ANNEXURE C

Mosquito Risk Assessment
Proposed Residential Development
Lot 2 DP 1119830
Alexandra Drive
Bellwood

Supplementary Engineering Information by De Groot Benson Pty Ltd

**DEVELOPMENT APPLICATION NO, 2012/011, 346 LOT RESIDENTIAL
SUBDIVISION PLUS RESIDUE AND ASSOCIATED WORKS - STAGED,
LOT: 2 DP: 1119830 ALEXANDRA DRIVE, NAMBUCCA HEADS
Supplementary Engineering Information**

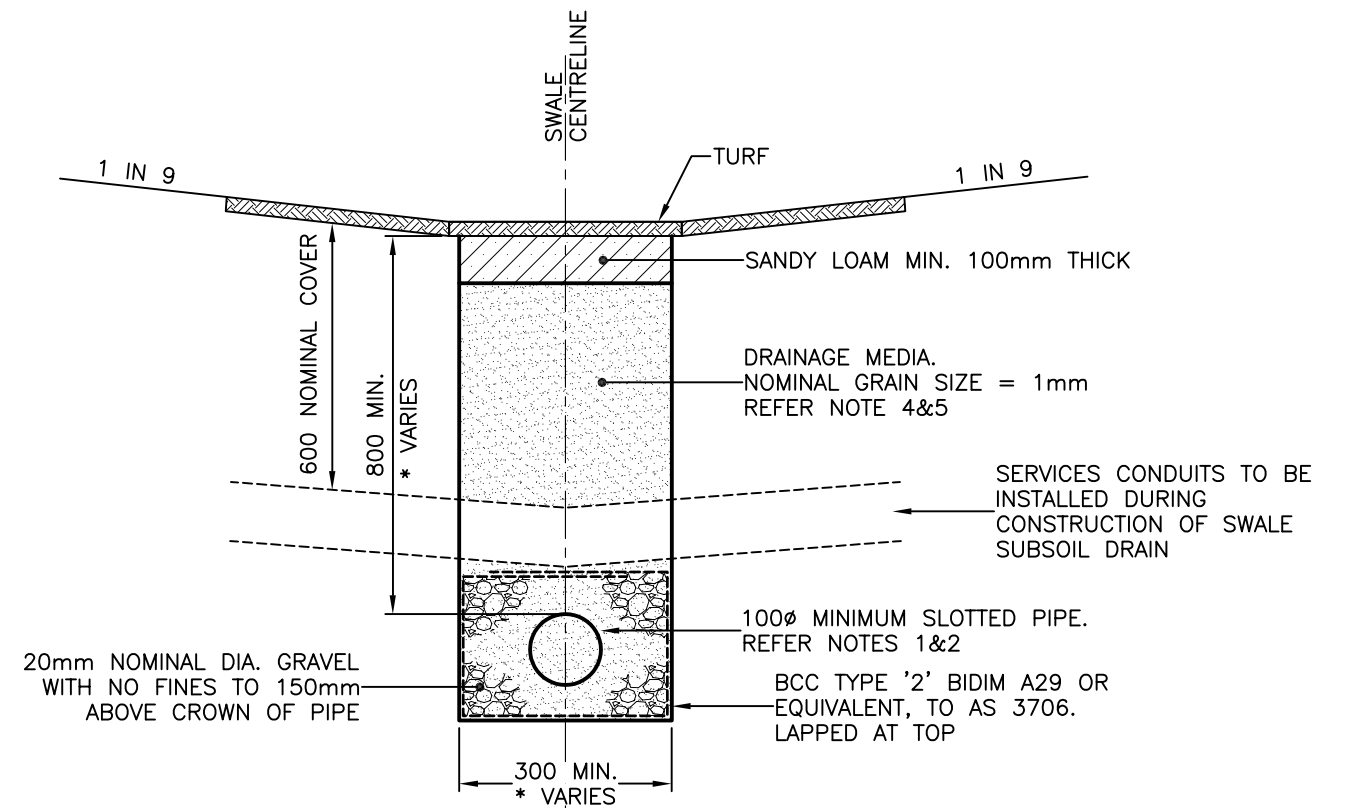
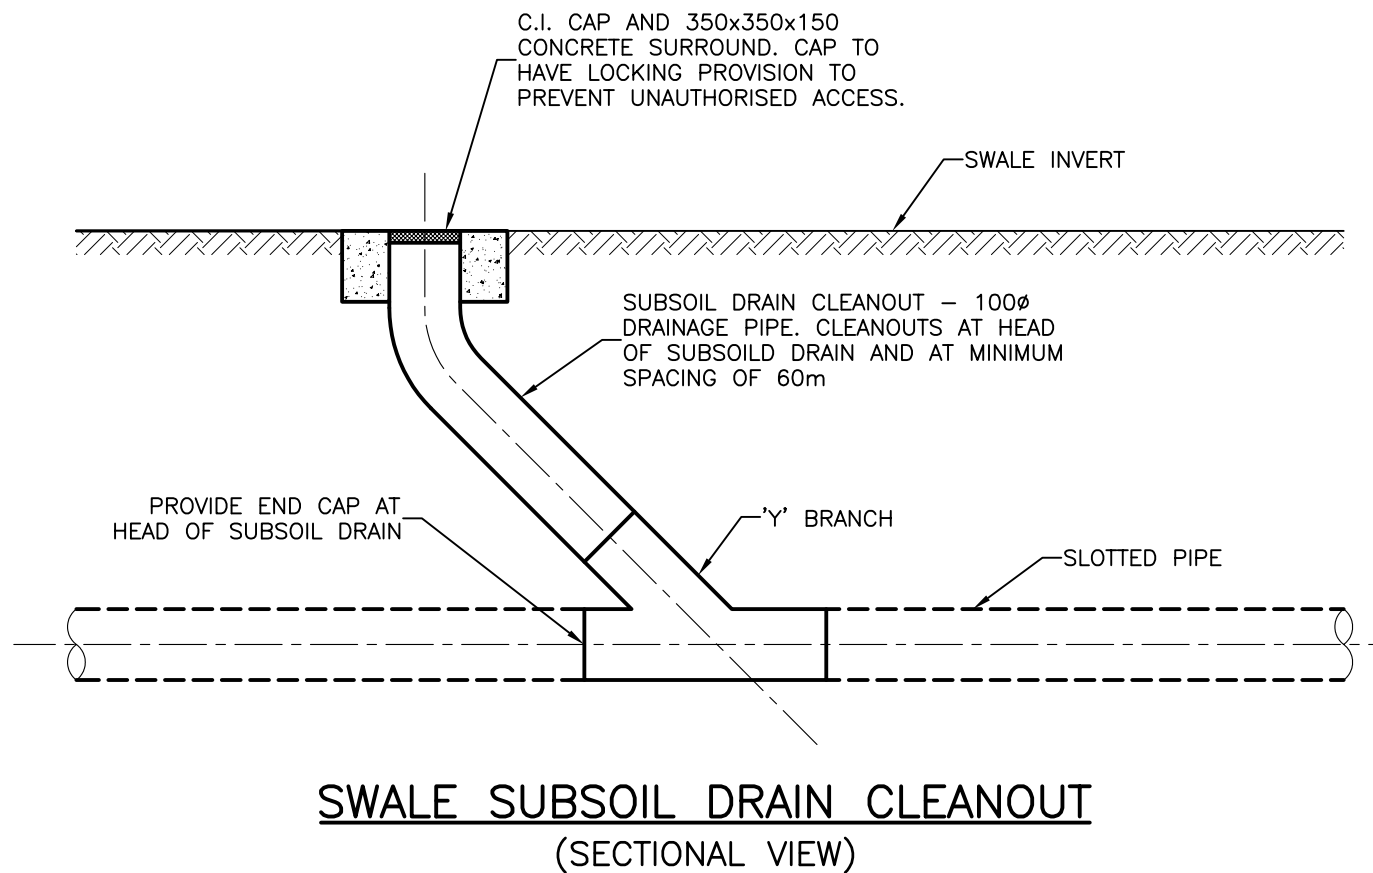
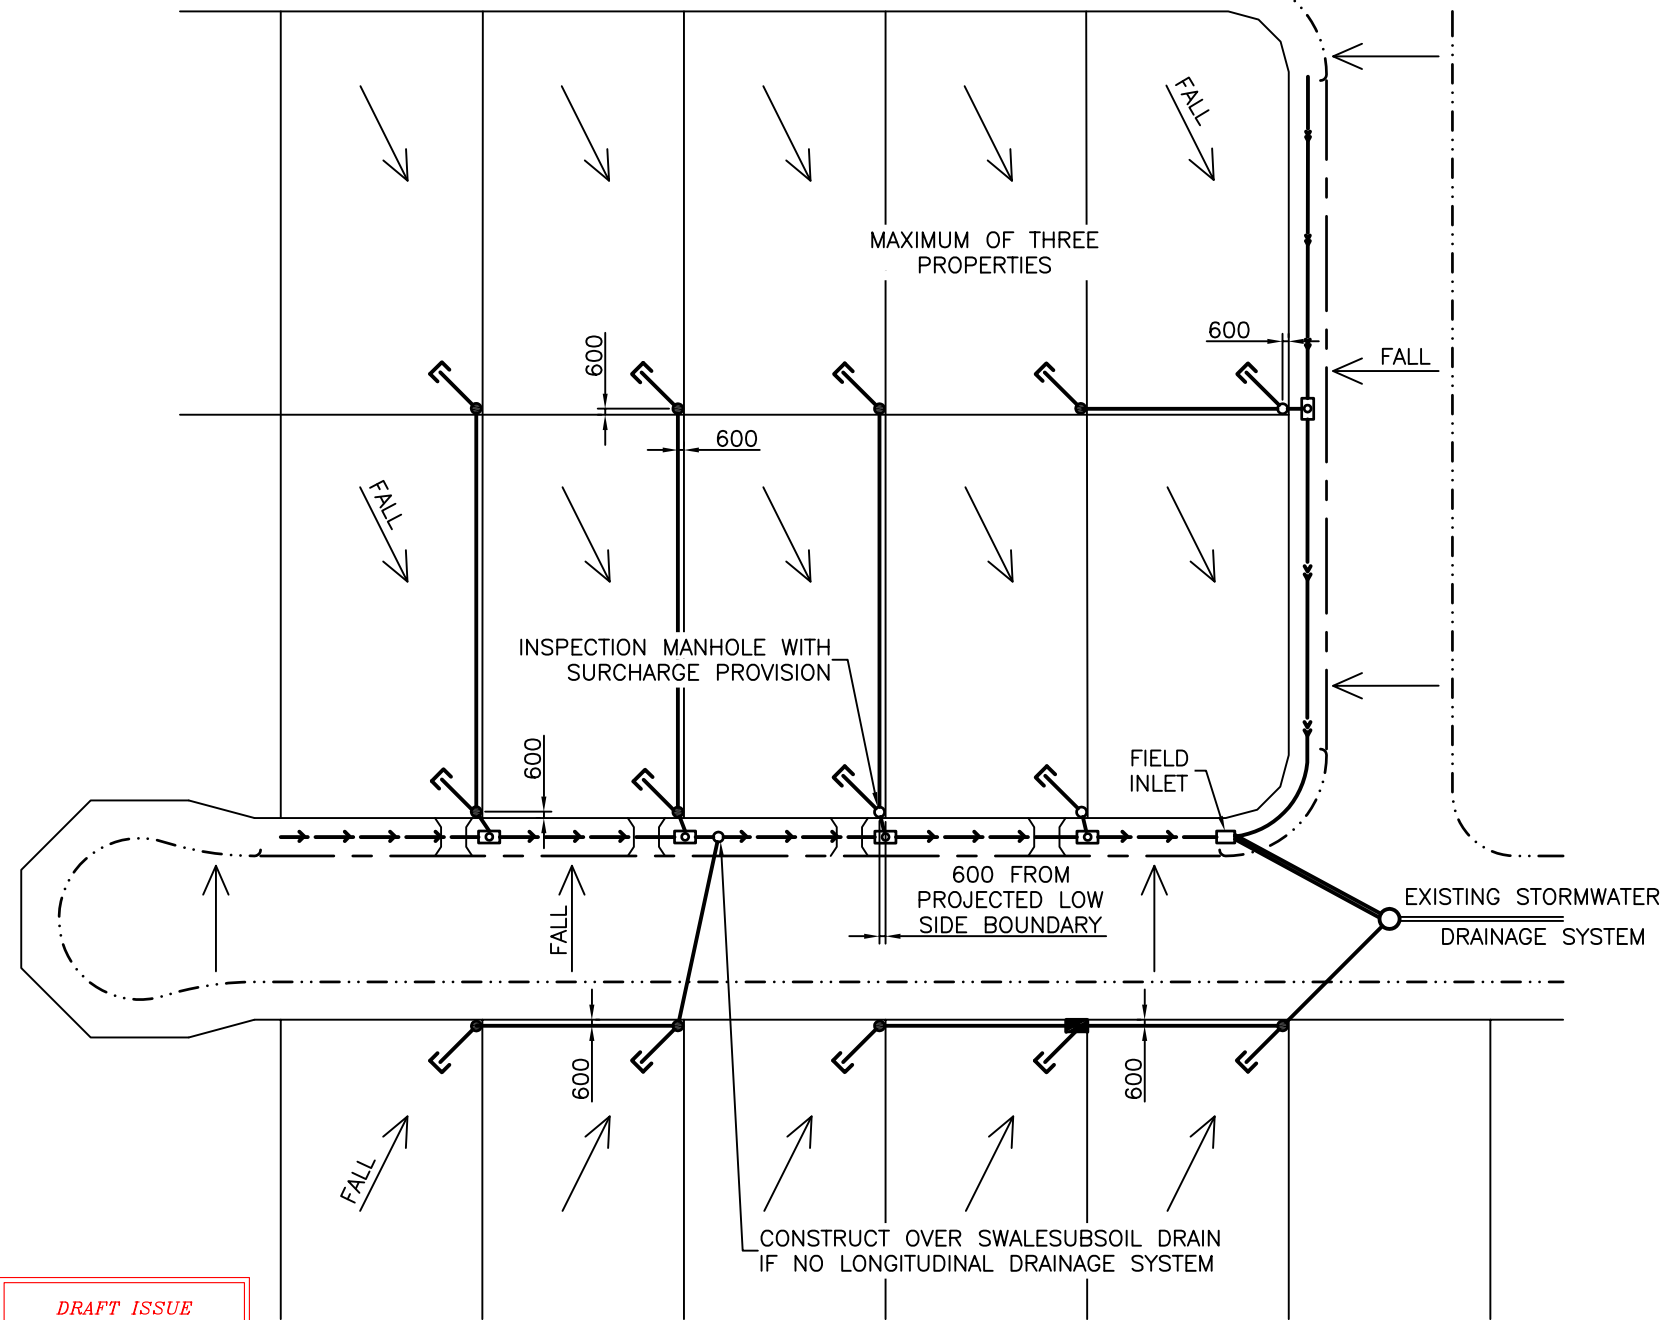
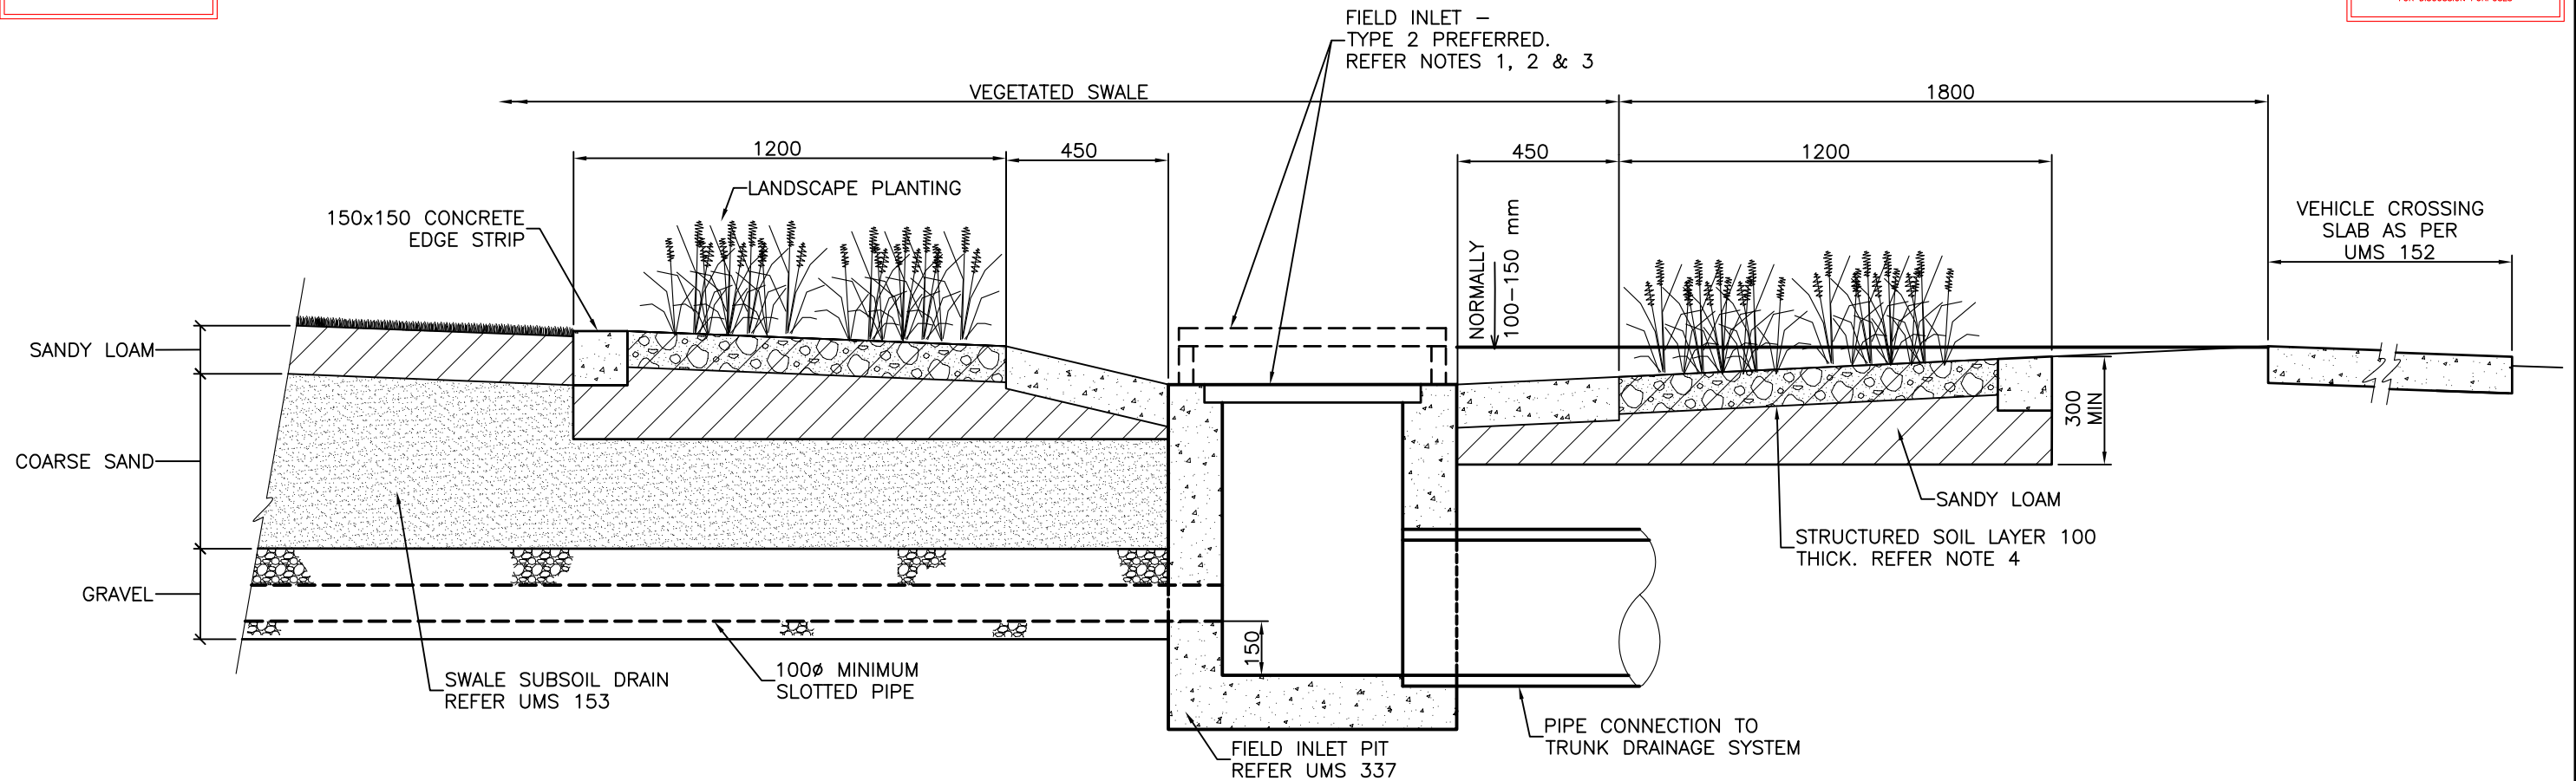
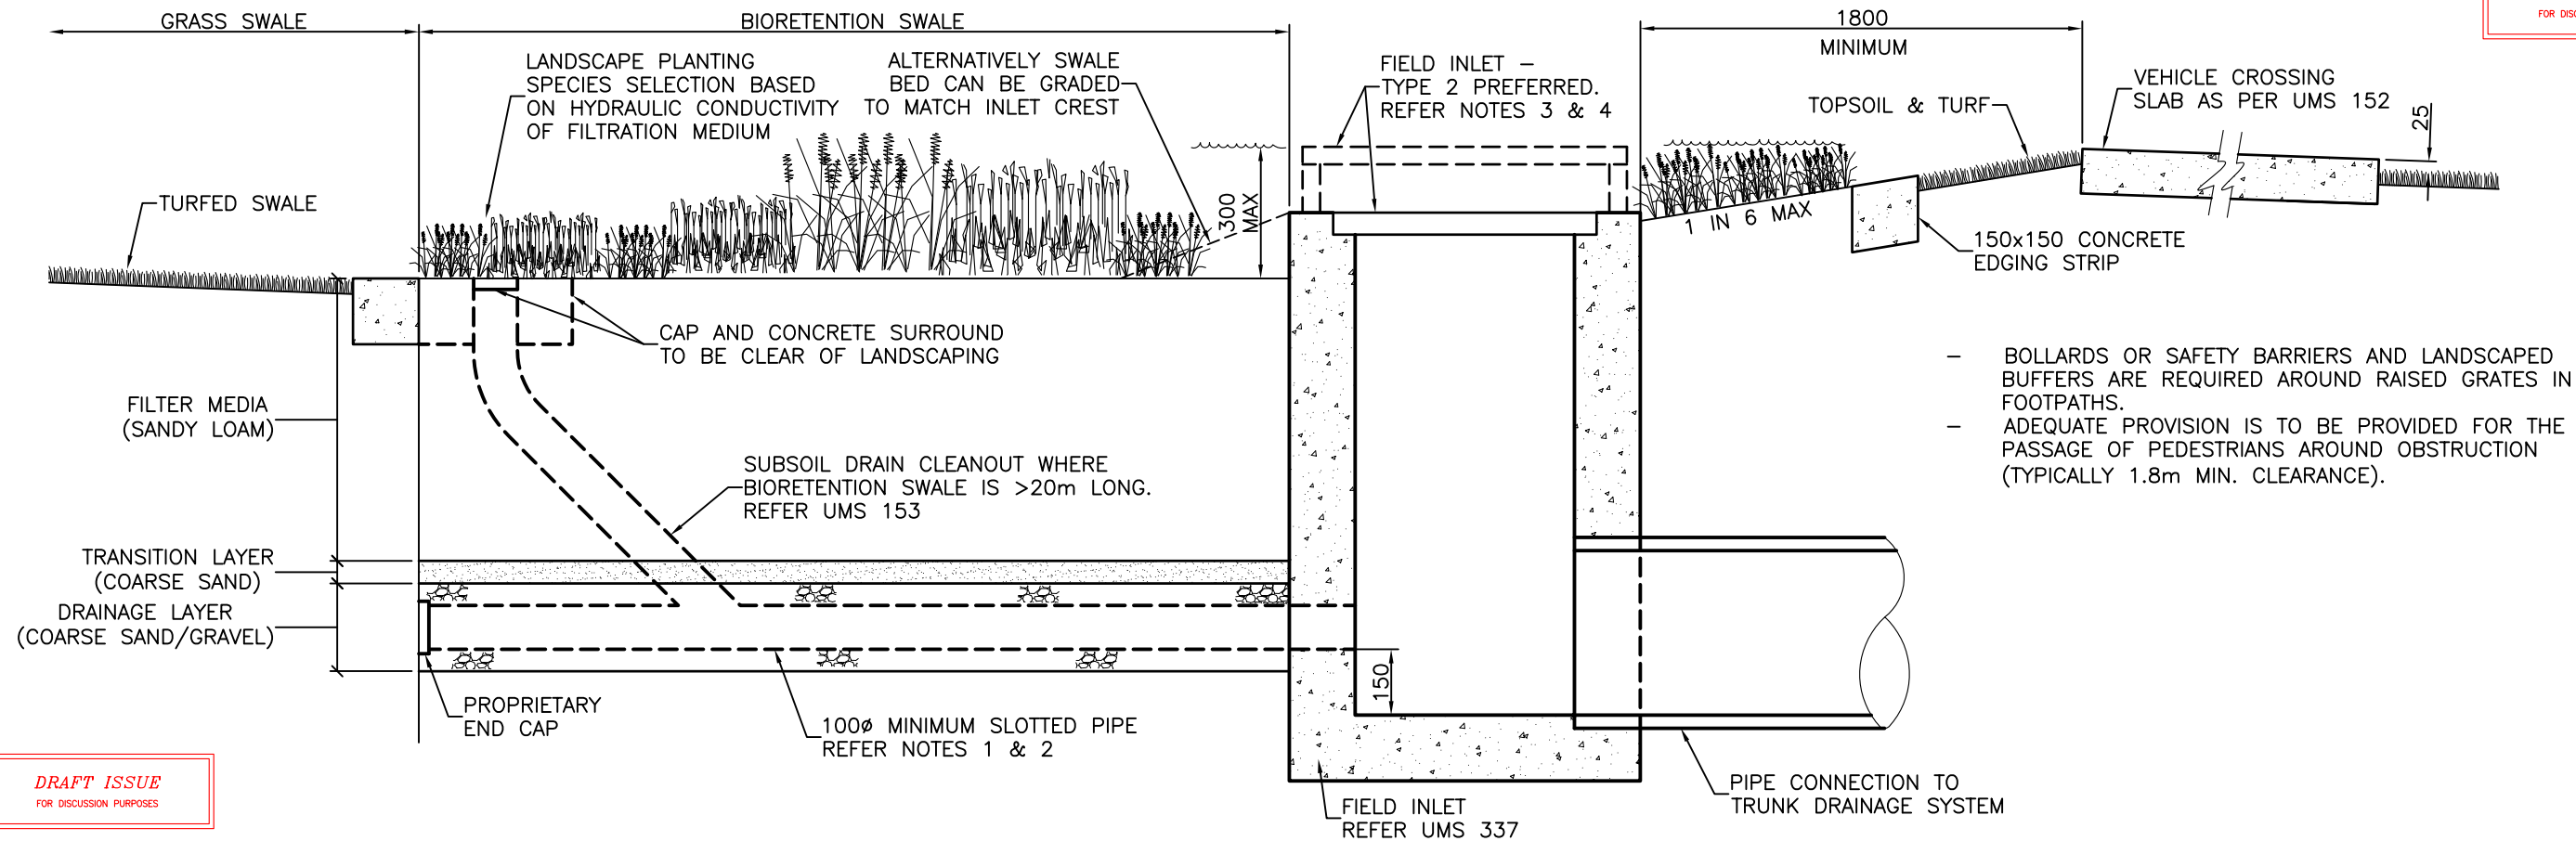
f) . Proposed kerb and gutter and swale drain design details for the proposed internal roads to the development, including relevant cross sections	In the absence of specific design guidelines from Nambucca Shire Council, we have proposed (like Coffs Harbour City Council) using those from Brisbane City Council and the South East Queensland region. Attached are standard drawings proposed for use in the design of the WSUD elements in the development.
